PROJECT: Thornton to Newkirk Watermain Improvements
City Project No. WA2010-01

ADDENDUM NO. 1
To the Contract Documents for:
City of Ferndale, Washington
Thornton To Newkirk Watermain Improvements Project

City of Ferndale Project No. WA2010-01

WATER TRENCHING DETAIL

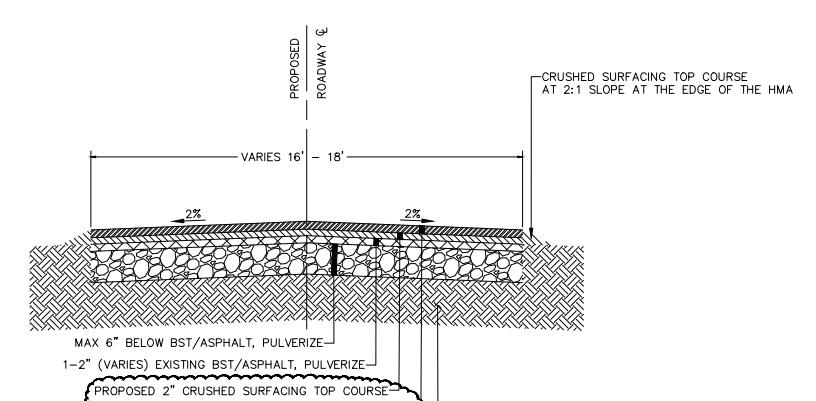
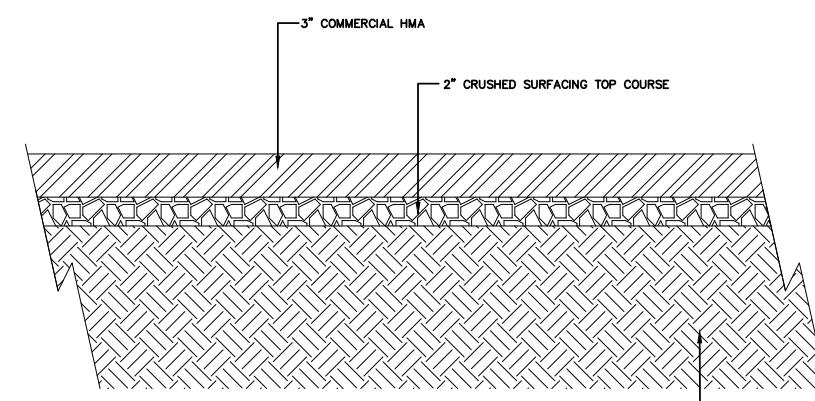
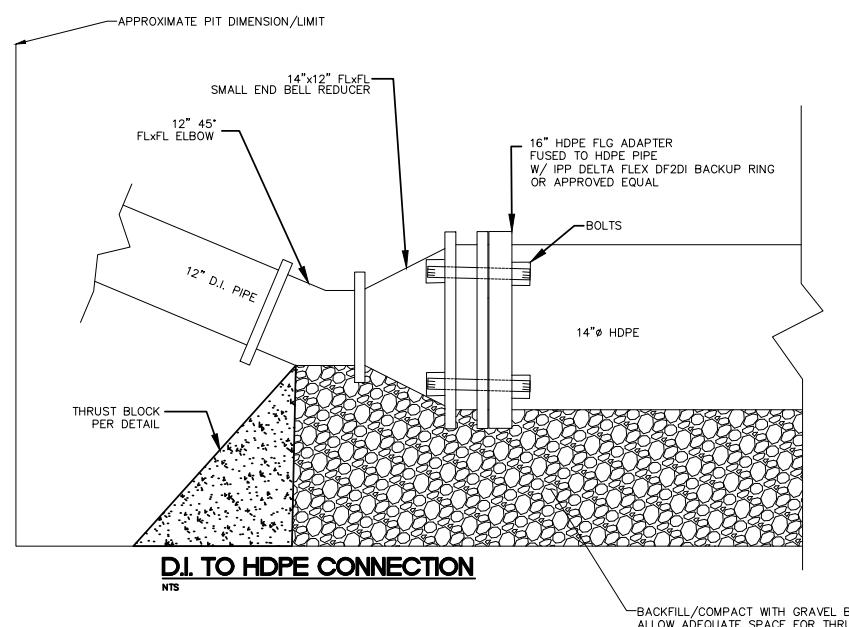
Sheets 14, the pavement pulverizing detail is revised.

1. NATIVE BACKFILL SHALL BE COMPACTED TO 90% RELATIVE COMPACTION.
2. SELECT BACKFILL/CRUSHED SURFACE COURSE SHALL BE COMPACTED TO 95% COMPACTION.
3. PAVEMENT SHALL BE SAW CUT, TACKED, AND COMPACTED TO 92% OF ABSOLUTE DENSITY.
4. P.C.C. REPLACEMENT SHALL BE 2" GREATER THAN EXISTING COURSE, 7" MINIMUM, 6.5 P.C.C. (HEC - AIR ENTRAINED)
5. ALL TRENCH RESTORATION SHALL MEET CITY STANDARDS.
